80C186XL AND 80C188XL EMBEDDED MICROPROCESSORS SPECIFICATION UPDATE

Release Date: July, 1996

Order Number 272895-001

Figure 1. Correct INT 1 Acknowledge Sequence With Higher Priority Timer Interrupt

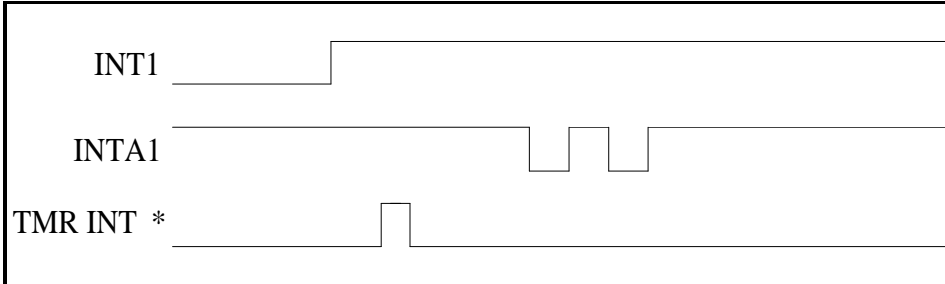
Correct operation of the device acknowledges the interrupt on INTA1# after an interrupt on INT1. Normally, this occurs even if there is a higher priority interrupt after INT1 but before the acknowledge (Figure 1).

Figure 2. Incorrect INT 1 Acknowledge Sequence With A Higher Priority Timer Interrupt

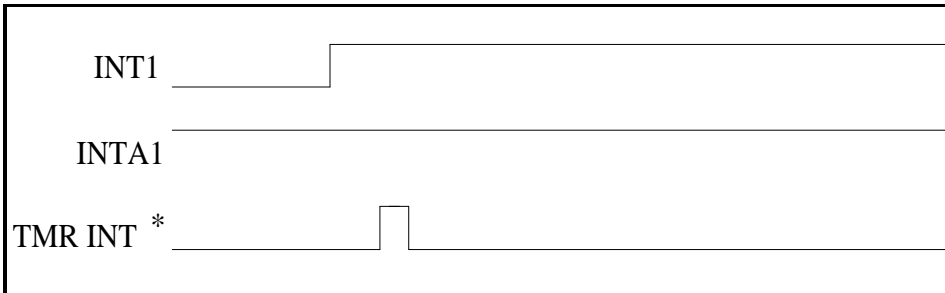
The errata occurs when a higher priority interrupt occurs between INT 1 and its expected acknowledge. The processor completes internal interrupt acknowledge cycles as seen on the status lines but no acknowledge cycle is sent on the INTA1# output (Figure 2).

Figure 3. INT 0 And INT 1 Acknowledge Failure Due To Higher Priority Timer Interrupt

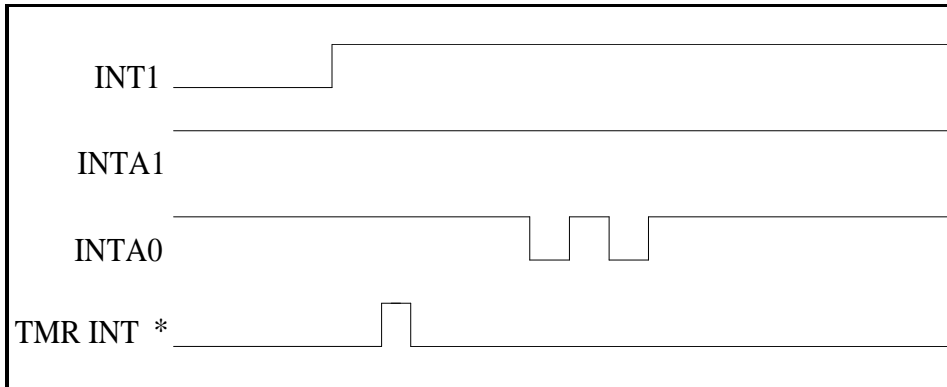
If INT 0 and INT 1 are configured in cascade mode and a higher priority interrupt occurs between INT 1 and its expected acknowledge, then the acknowledge will appear on INTA0# instead (Figure 3).

Figure 4. Correct INT 0 Acknowledge operation with a simultaneous INT 1

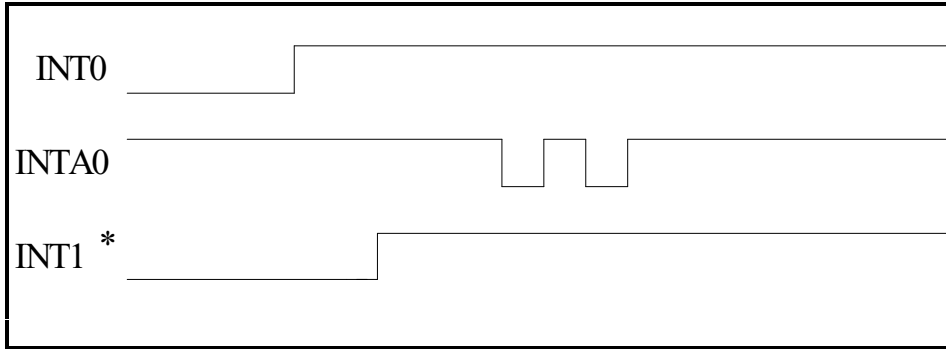
Correct operation acknowledges INT 0 on INTA0#. Normally, this occurs even if there is a higher priority INT 1 after INT 0 but before the acknowledge (Figure 4).

Figure 5. Incorrect INT 0 Acknowledge operation with a simultaneous INT 1

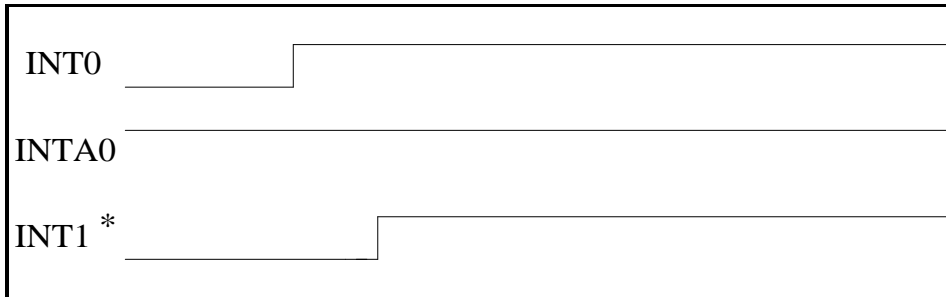
The errata occurs when INT 1, which is higher priority than INT 0, occurs between INT 0 and its expected acknowledge. The processor completes internal interrupt acknowledge cycles as seen on the status lines but no acknowledge cycle is sent on the INTA0# output (Figure 5).

Figure 6. INT 0 and INT 1 Acknowledge Failure due to the higher priority INT 1.

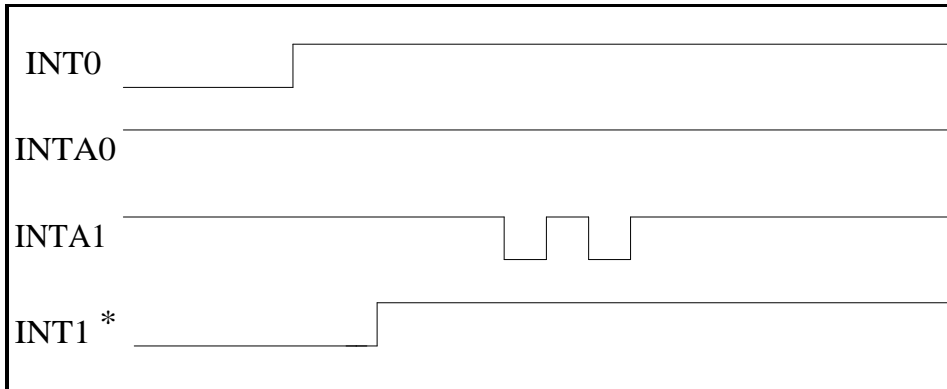
If INT 0 and INT 1 are configured in cascade mode and the higher priority INT 1 occurs between INT 0 and its expected acknowledge, then the acknowledge will appear on INTA1# instead of INTA0# (Figure 6).
